Office Action Summary	Application No. 10/523,896	Applicant(s) WINN ET AL.	
	Examiner Daniel Tucker	Art Unit 4159

DETAILED ACTION

5. Claims 1-11 and 13-21 are rejected under 35 U.S.C. 103(a) as being unpatentable over German Patent No. 3,633,348 A1 (Siegfried hereinafter) in view of US Patent No. 5,161,709 (Oestreich, Jr. hereinafter) and US Patent No. 1,129,040 (McClure hereinafter).

Fig. 1 of US Patent No. 1,129,040 (McClure hereinafter)

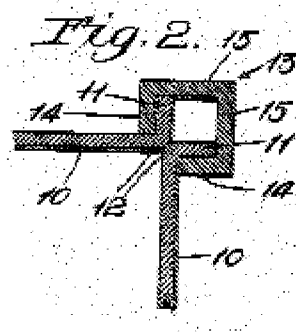
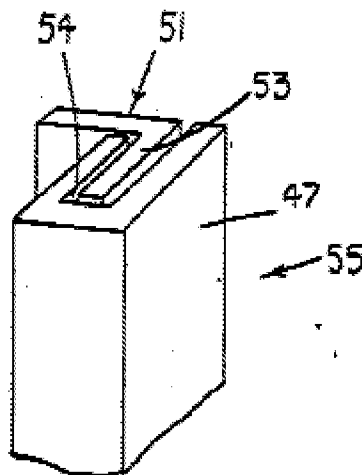
7. With reference to Fig. 1 and Fig. 2 of McClure above, McClure discloses a “first elongate perimeter frame attachment members (13) attached to and extending along opposite vertical margins of each of the side gates and each having a laterally inwards directed locking flange (14) which lies in a plane parallel to the plane of the inner face of said infill panel and spaced inwardly therefrom,”

10. In re Claim 2, with reference to Fig. 1 and Fig. 2 of McClure above, McClure discloses “each said first perimeter frame attachment (13) member is an approximate C-section post which terminates at one of its ends in said laterally inwards directed locking flange (14), the free edge of said locking flange being spaced laterally outwards from the vertical margin of the outer frame, and at its other end in an inturned inwardly directed attachment flange arranged to be attached to a respective said vertical margin.”

26. With reference to Fig. 1 and Fig. 2 of McClure above, McClure discloses “a corner post member (13) detachably secured to and abutting respective said vertical margins, said post member having a pair of inwardly directed locking flanges (14).”

**FIG. 12****Fig. 12 of US Patent No. 5,161,709 (Oestreich, Jr. hereinafter)**

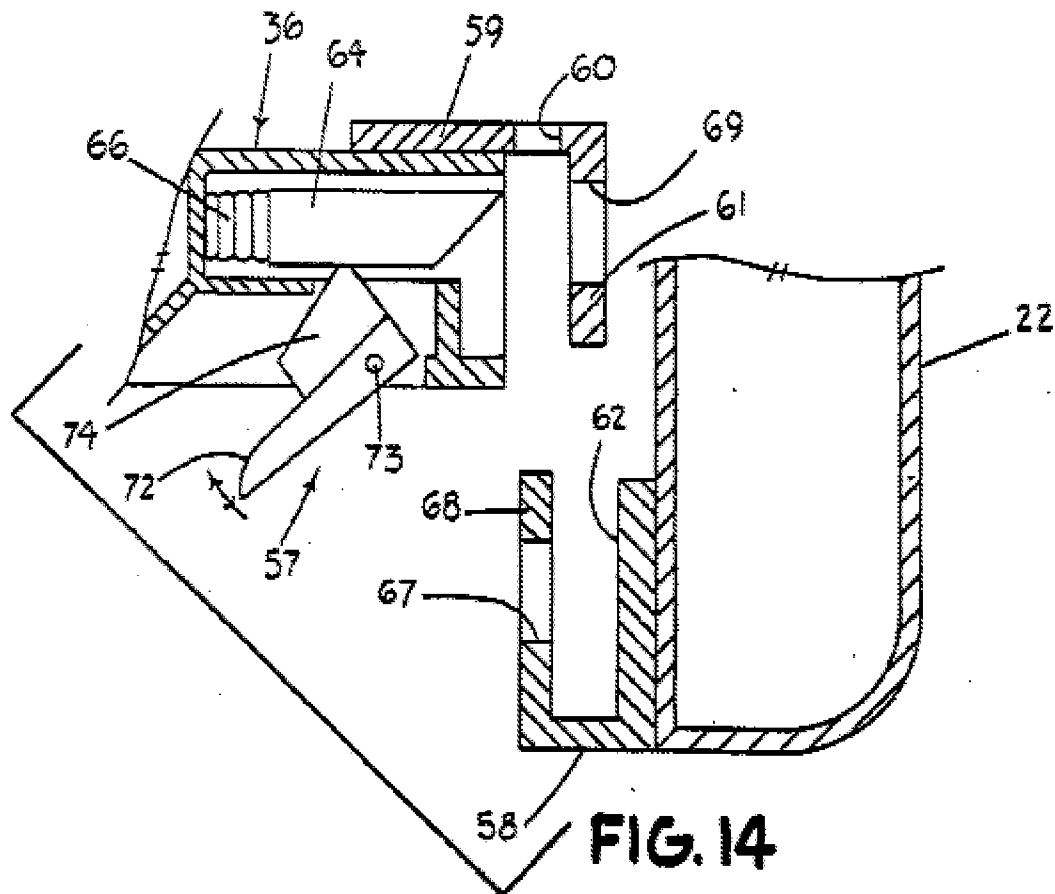
8. With reference to Fig. 12 and Fig. 14 above, Oestreich, Jr. discloses:
- second elongate perimeter frame attachment members (51, 59) attached to and extending along opposite vertical margins of each of the end gates (36) and defining therewith an outwardly opening locking flange receiving slot,
 - said first and second frame attachment members, when the container is in its erect in-use condition, interlocking with one another with said locking flanges located in respective said flange receiving slots (Fig. 12), and
 - locking means (57, 64, 66, 72, 73, and 74) to releasably lock the first and second frame attachment members against relative movement when in their interlocking

13. In re Claim 19, with reference to Fig. 12 and Fig. 14 above, Oestreich, Jr. discloses "each said side gate (36) is provided with an angle section frame member (51, 59) extending along each of its vertical margins, each angle section frame member having one of its flanges abutting the inner face of the infill panel, and its other flange (53, 61) extending rearwardly and lying parallel to a vertical margin of the outer perimeter frame, said other flange being spaced from said vertical margin so as to define an elongate slot for receiving a respective said attachment flange of a said C-section post."

15. In re Claim 6, with reference to Fig. 12 and Fig. 14 above, Oestreich, Jr. discloses “each said side gate (36) is provided with an angle section frame member (51, 59) extending along each of its vertical margins, each angle section frame member having one of its flanges abutting the inner face of the infill panel, and its other flange (53, 61) extending rearwardly and lying parallel to a vertical margin of the outer perimeter frame, said other flange being spaced from said vertical margin so as to define an elongate slot for receiving a respective said attachment flange of a said C-section post.”

16. In re Claim 14, with reference to Fig. 12 and Fig. 14 above, Oestreich discloses “said second perimeter frame (51, 59) attachment member is of angle cross-section having one flange contiguous with the inner face of its associated said infill panel, and its other flange (53, 61) projecting outwardly and lying parallel with a respective said vertical margin of the gate and spaced therefrom so as to form a respective said flange receiving slot which extends approximately the length of the vertical edge of the gate.”

22. In re Claim 3, with reference to Fig. 12 and Fig. 14 above, Oestreich discloses “said second perimeter frame (51, 59) attachment member is of angle cross-section having one flange contiguous with the inner face of its associated said infill panel, and its other flange (53, 61) projecting outwardly and lying parallel with a respective said vertical margin of the gate and spaced therefrom so as to form a respective said flange receiving slot which extends approximately the length of the vertical edge of the gate.”

30. In re Claim 9, with reference to Fig. 12 and Fig. 14 above, Oestreich, Jr. discloses “each of the side gates has an elongate angle frame member (51, 59) extending along each of its vertical margins with one of its flanges abutting the inner face of the infill panel and its other said outwardly directed flange (53, 61) extending parallel to the vertical margin of the gate and spaced outwards therefrom so as to define said outwardly opening flange receiving slot extending along the entire length of the vertical edge of the gate.”

31. In re Claim 10, with reference to Fig. 12 and Fig. 14 above, Oestreich, Jr. discloses “said locking means comprise slidable latch bolts (64) mounted in the region of the upper and lower corners of a respective said gate, each said bolt, when in its latching position, respectively passing through aligned holes (67, 69) formed in the flanges.”
